## PRODUCT UPDATE: 8240P SERIES

(The 6240P Series has been discontinued and the 8240P Series has been re-designed to incorporate this option)

### WIRING DIAGRAM

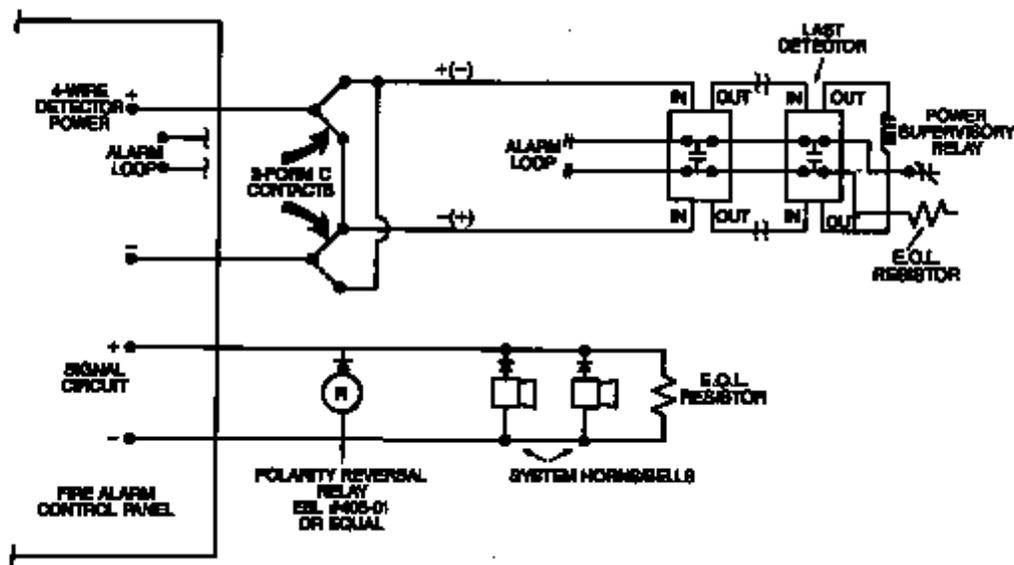
The 8240P(Y) & 8240PH(Y) are 4-wire detectors equipped with integral piezo-electric signals. These internal signals are activated upon detection of smoke at the detector or alarm or upon reversal of polarity of the detector power. This application enables the integral piezo to operate either as a local evacuation signal or as a system signalling device.

The most likely application would be an 8240PY or 8240PHY. The detector would be used as a local smoke detector with the alarm contacts **not** connected to the alarm loop of the control panel. In this manner, upon detection of smoke, the piezo would sound at the detector or alarm and restore to normal after smoke clears. If equipped with the isolated thermal (H option), the thermal contact would be connected to the alarm loop. If any device connected to the alarm loop is activated the alarm panel is put into an alarm condition which activates the polarity reversal relay which activates the piezo signals in all connected 8240PY/8240PHY smoke detectors. The piezo would continue to sound until the panel is reset or until the alarm/signal silence is manually operated at the panel.

- 1) When energized by reverse polarity only the piezo signal is activated within the detector. The auxiliary and alarm contacts and alarm LED are not energized unless the unit detects smoke.

- 2) While operating in reverse polarity mode, the detector may still detect smoke and operate, thus activating all relays and LED.
- 3) The polarity reversal relay should be connected to the signal circuit of the panel so that the signals will silence upon operation of the "Alarm Silence" button at the fire alarm control panel.

- 4) The contacts of the reversal polarity relay must be of adequate rating to carry the current load of all connected integral detector signals.
- 5) The reverse polarity relay must be polarized with a blocking mode to provide for supervision of the signal circuit.

- 6) The power supply of the fire alarm control panel must be sized to provide for simultaneous and continuous operation of all integral piezo signals.

- 7) If latching detectors are used, it will be necessary to operate the 4-wire detector reset at the fire alarm control panel to reset any detectors in actual alarm condition.
